Access Compliance Report

Public Rights-of-Way

(Curb Ramps)

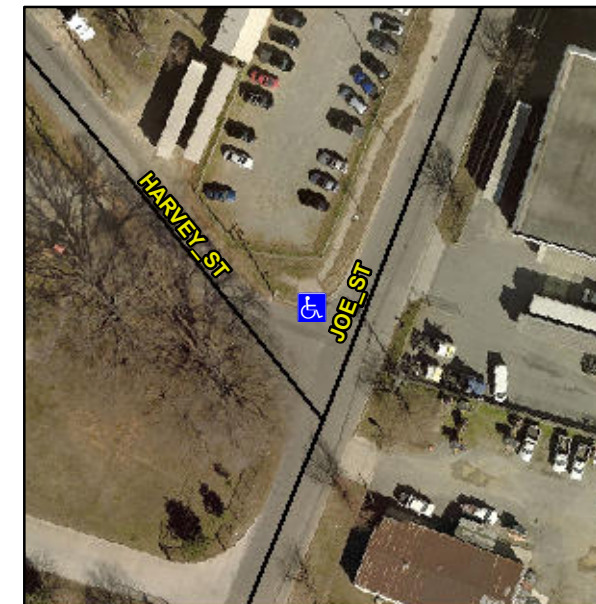
Not Found, R304.5.1, R304.5.3

Compliance	Description	Data	Compliance	Description	Data
N/A	Ramp Length (in)	94.5	Yes	Ramp Slope (%)	7.5
No	Ramp Width (in)	44.5	No	Ramp XSlope (%)	6.8
N/A	Flare Type LT	N/A	N/A	Flare Type RT	N/A
N/A	Flare Slope LT (%)	N/A	N/A	Flare Slope RT (%)	N/A
N/A	Flare Traversable LT?	N/A	N/A	Flare Traversable RT?	N/A
N/A	Landing Length (in)	N/A	N/A	DWS Provided?	N/A
N/A	Landing Width (in)	N/A	N/A	DWS Contrast?	N/A
N/A	Landing Slope (%)	N/A	N/A	DWS Length (in)	N/A
N/A	Landing X Slope (%)	N/A	N/A	DWS Full Width?	N/A
N/A	Landing Curb? (Y/N)	N/A	N/A	DWS Offset (in)	N/A
N/A	Shared Landing?	N/A			
N/A	Gutter Ponding?	N/A	N/A	Gutter Slope (%)	N/A
N/A	Gutter Lip Ht (in)	N/A	N/A	Gutter X Slope (%)	N/A
N/A	Painted X Walk1?	No	N/A	Painted X Walk2?	N/A
	X Walk 1 Direction	To S		X Walk 2 Direction	N/A
N/A	X Walk 1 Width (in)	N/A	N/A	X Walk 2 Width (in)	N/A
	X Walk 1 Slope (%)	4.5		X Walk 2 Slope (%)	N/A
	X Walk 1 X Slope (%)	6.7		X Walk 2 X Slope (%)	N/A

Remove & Replace Entire Ramp.
